Service Bulletin

SUBJECT: Service Update for Inventory and Customer Vehicles
Rear Door Inside Handle Release Cable Misrouted
Expires with Base Warranty

MODELS: 2014-2015 Cadillac CTS Sedan (VIN A)

3997960

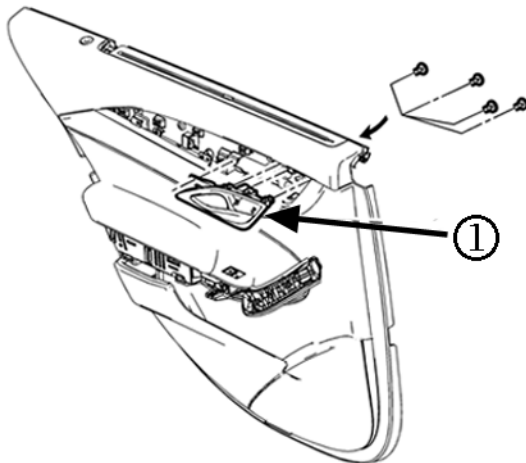
1. Remove the rear side door latch (1) and the rear side door inside handle cable (2) from the affected door. Refer to *Rear Side Door Inside Handle Cable Replacement* in SI.

3997967

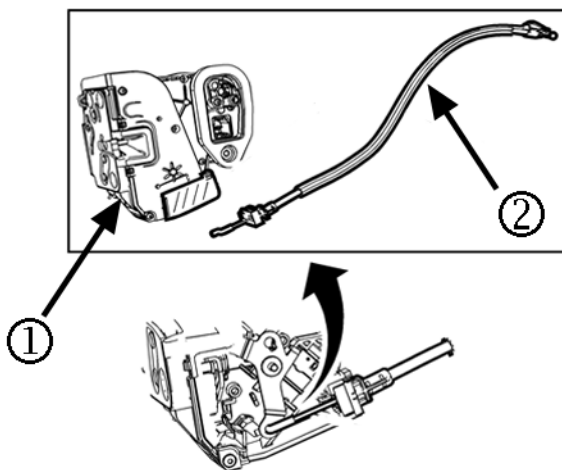
Note: When installing the new rear side door inside handle cable, ensure proper routing of the cable within the door. As shown in the graphic above, the cable **MUST** be routed on the inboard side (1) of the vertical glass channel, **NOT** the outboard side (2).

- 4. Install a new rear side door latch (1) and new rear side door inside handle cable (2) to the affected door. Refer to *Rear Side Door Inside Handle Cable Replacement* in SI.
- 5. Prior to installing the door trim panel, verify proper operation of the door glass lowering fully into the door.
